CABINET MEMBER FOR ENVIRONMENT– 21 MAY 2015

PROPOSED PEDESTRIAN CROSSING, A4260 OXFORD ROAD/BROAD GAP, BODICOTE

Report by Deputy Director for Environment & Economy (Commercial)

ANNEX 1

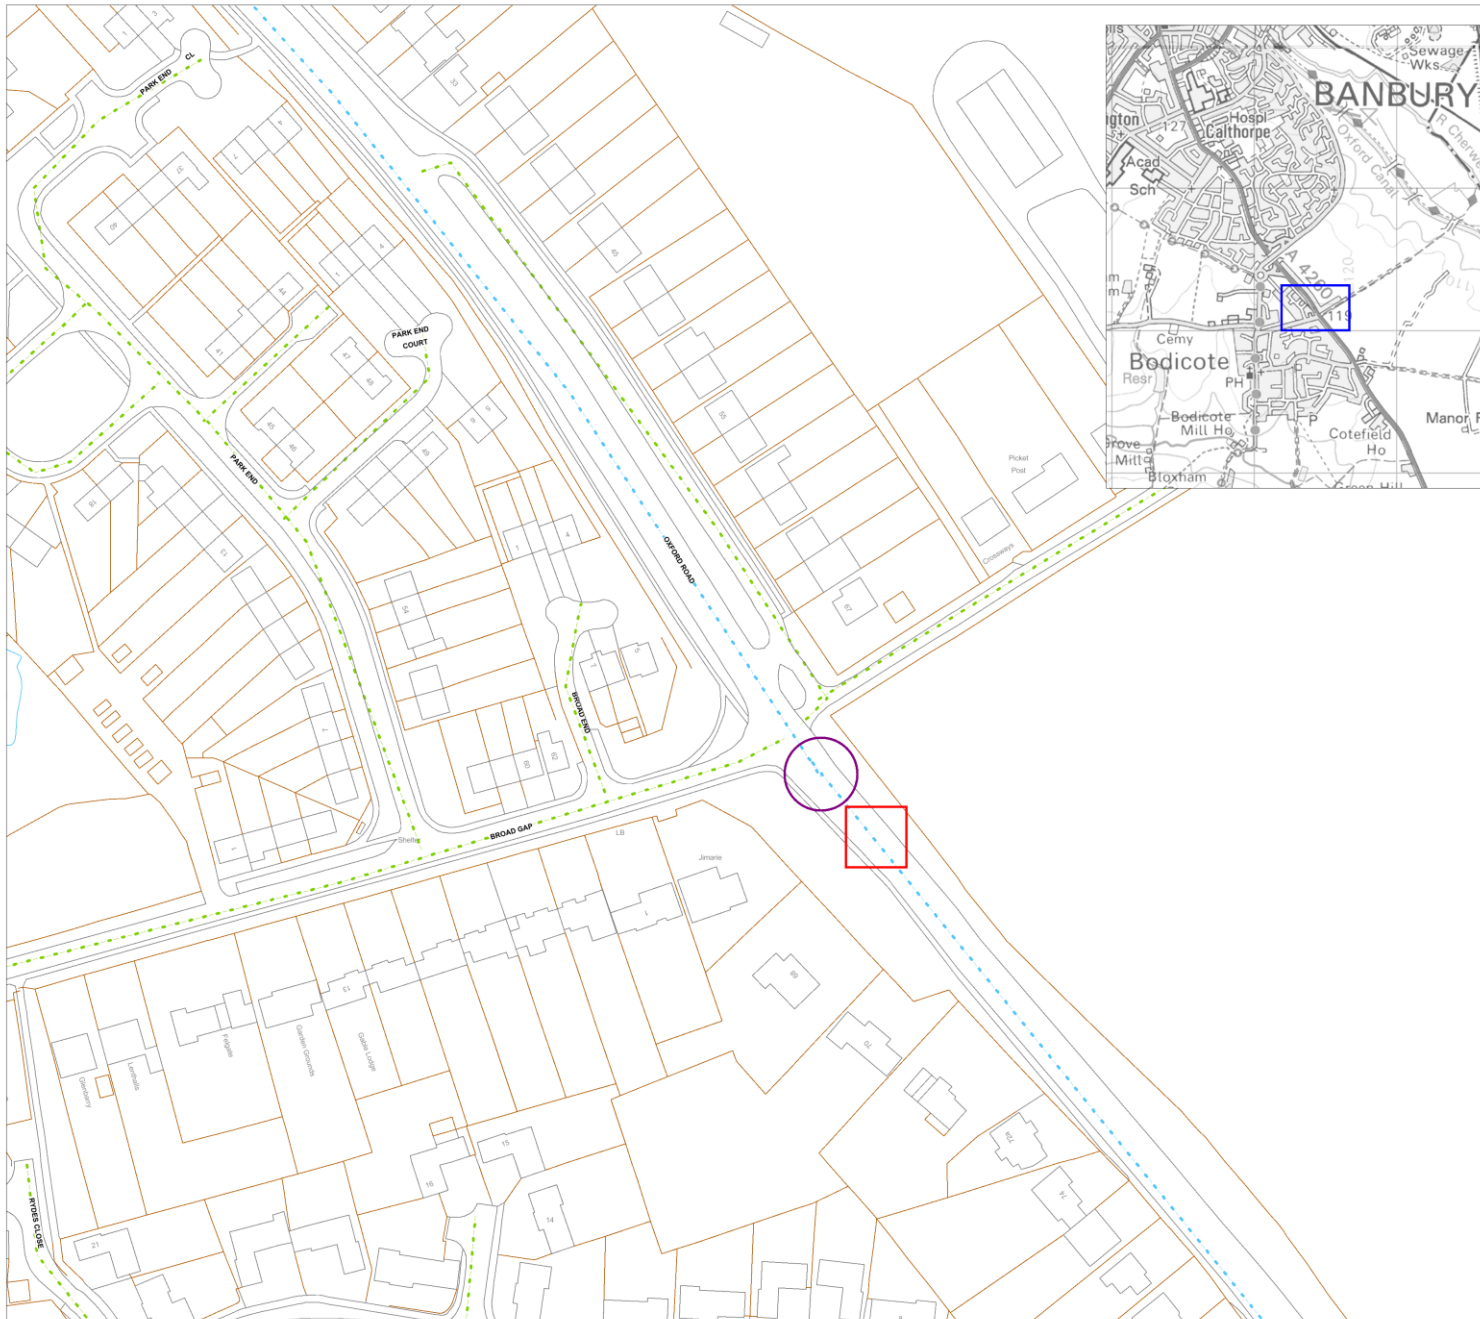
6. Both the Parish and the member of the public were concerned at the distance between the proposed location of the crossing and the junction at Broad Gap, believing it was too close and thus a safety concern. It was also

stated that the junction is already busy at peak times, and that by adding a crossing at the proposed location delays currently experienced by traffic wishing to turn right from Broad Gap onto the A4260 would increase.

7. Finally, there was a concern that the crossing would go across the layby/slip road and bus stop, which would cause delay for traffic moving north on the A4260 as buses would cause a blockage and also that vehicles would no longer have access to the slip road to exit left into Broad Gap.

8. Significant pedestrian movements are expected on the footpath access in the north-west corner of the new development to gain access to the Oxford Road either to use the bus services into Banbury or to access local facilities such as the District Council Offices, the school, playing fields, the pub, and the village hall. Given the width of Oxford Road and the speed of traffic such crossings would be difficult without the proposals that have been developed.

9. The removal of the “false” slip lane/layby, the narrowing of the carriageway and the crossing will have the effect of reducing speeds on the Oxford Road, therefore making it easier for vehicles to exit Broad Gap. The crossing signals will be clearly visible from the Broad Gap junction.

10. The Parish Council have suggested that the crossing be installed to the north of Broad Gap in the vicinity of the current informal crossing point. However this location would be away from the pedestrian desire line, and would create other safety issues with some people not using the facility. There would also be the safety issue of reduced visibility for vehicles turning left out of Broad Gap, potentially into a red light, and the requirement for additional footway construction north of Canal Lane would make this alternative no less expensive than the existing proposal.

11. The need to relocate the northbound bus stop is accepted and if this is moved to the north of the junction it will mean that buses will be stopped in the carriageway for short periods, as is already the case for southbound buses. Proposals for the bus stop relocation will be subject to separate local consultation involving the Police and Parish Council in the usual way.

ANNEX 2

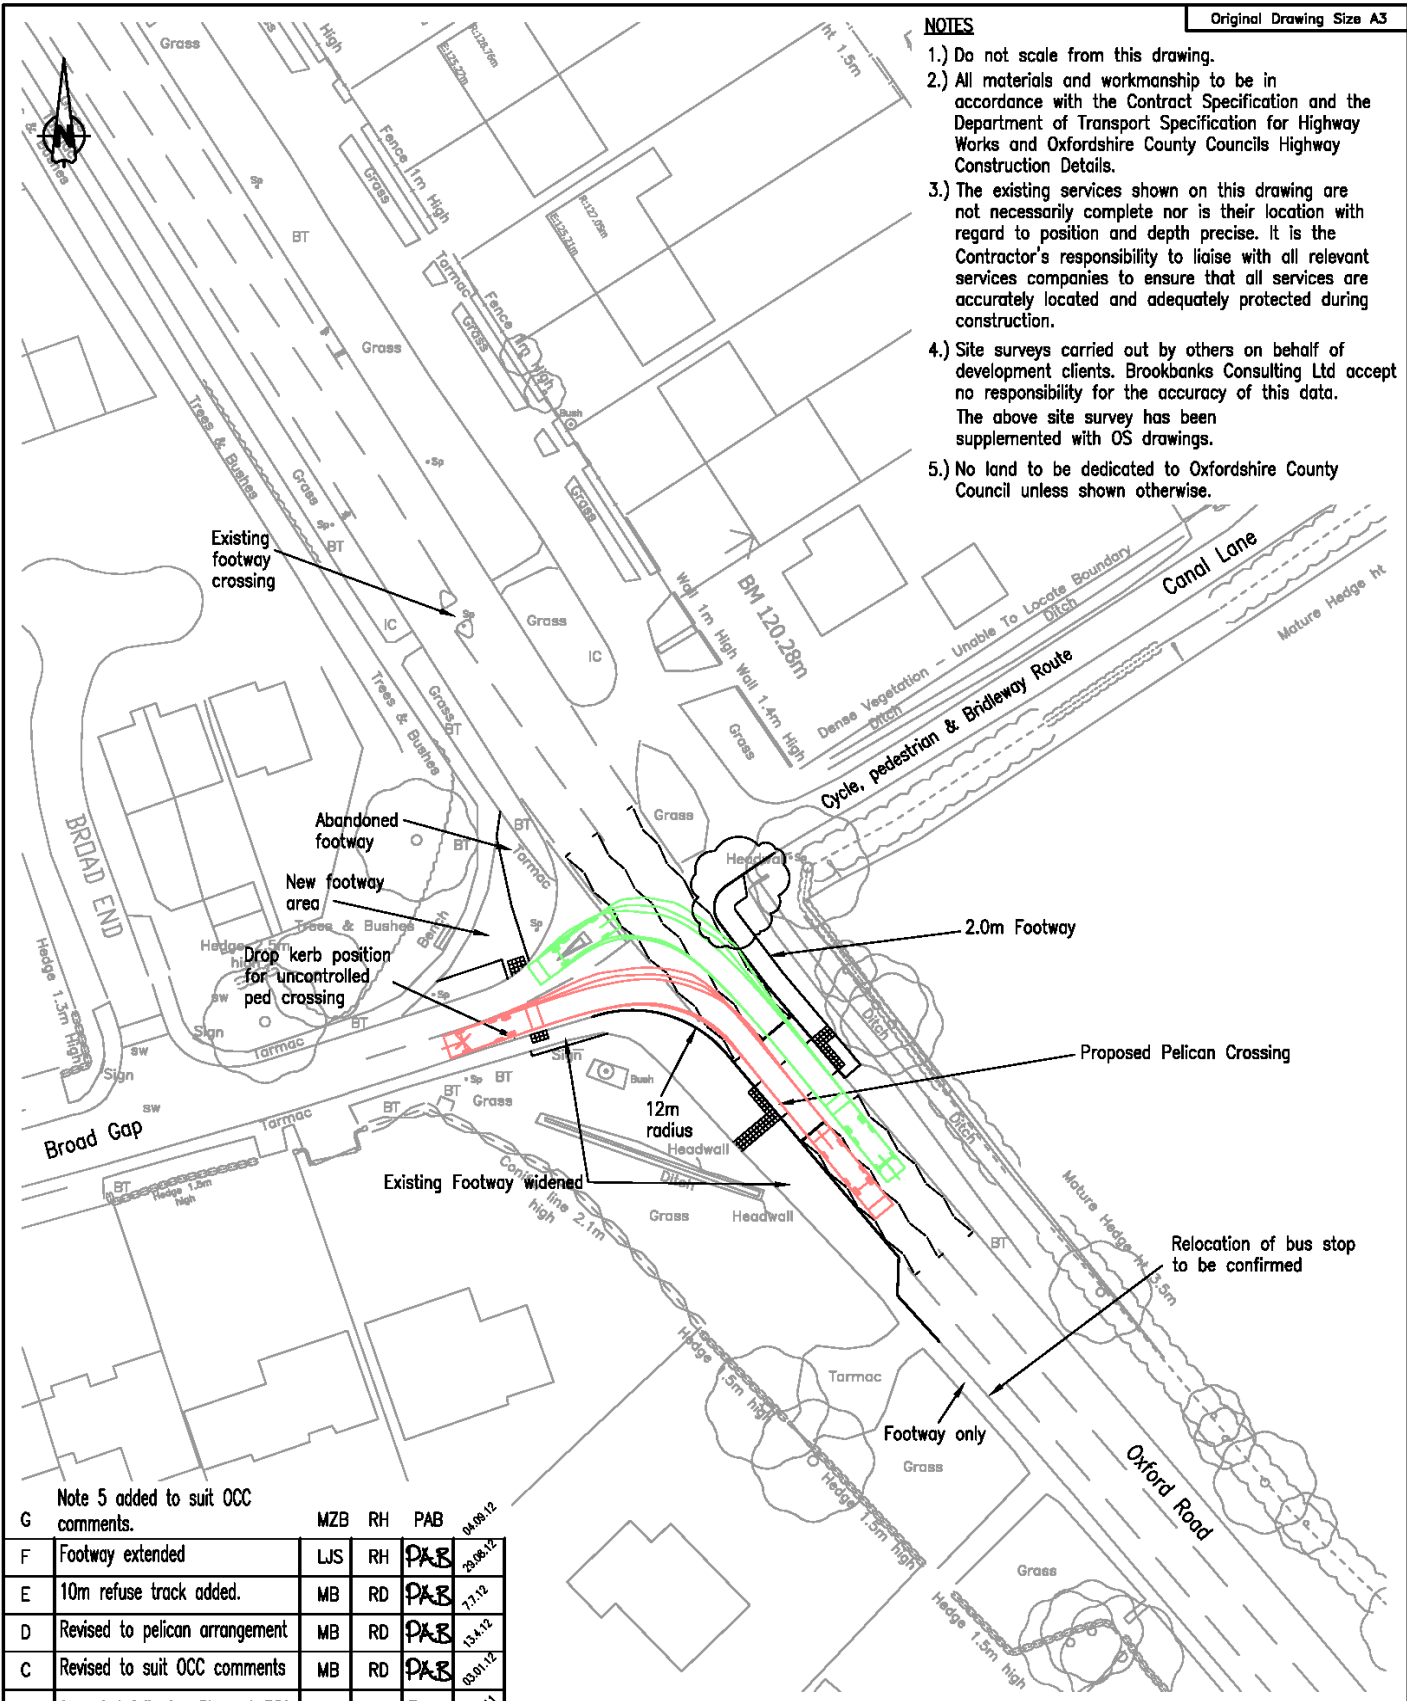
ID	RESPONDENT	SUMMARISED COMMENTS
1	Parish Council (Bodicote)	<p>Objects - due to the following reasons:</p> <ul style="list-style-type: none"> ▪ Crossing should be sited just north of Broad Gap, enabling traffic turning left to see stationary traffic at crossing and would allow vehicles to turn right without restriction, ▪ It would also save a considerable amount of money and disruption, ▪ The left turn lane allows traffic to flow freely to Banbury, ▪ If the bus lane is removed, buses will hold up traffic when stopping, ▪ This puffin crossing was agreed 10 years ago, we do not believe we have had the correct consultation, and the traffic situation is very different now from 10 years ago. <p>In summary we feel a proper review of the traffic situation should be undertaken and that this proposal from 10 years ago should not simply be given the go-ahead. Whilst it may conform to certain guidance from a traffic engineering point of view, we believe it does not chime with the actual situation on the ground.</p>

2	Thames Valley Police (Traffic Officer)	<p>No objection – but has the following comments:</p> <ul style="list-style-type: none"> ▪ Distance to the junction at Broad Gap may offer some hazard potential for those on the crossing and traffic emerging from Broad Gap turning right. ▪ Site lines are good with no obvious infrastructure that could compromise safety.
3	Member of public (via email)	<p>Objects - due to the following reasons:</p>

| | | <ul style="list-style-type: none">▪ The junction is very busy and is more and more used as a cut through, It can take 5mins to turn right out of Broad Gap to travel south on Oxford Road,▪ The crossing is too close to the junction and will be a distraction when trying to exit safely,▪ There is already a non-control crossing just to the North of the Broad Gap/Oxford Road junction, as this would allow cars turning right out of Broad Gap to do so safely,▪ The crossing will go across a layby/commonly used slip Road and the bus stop. |
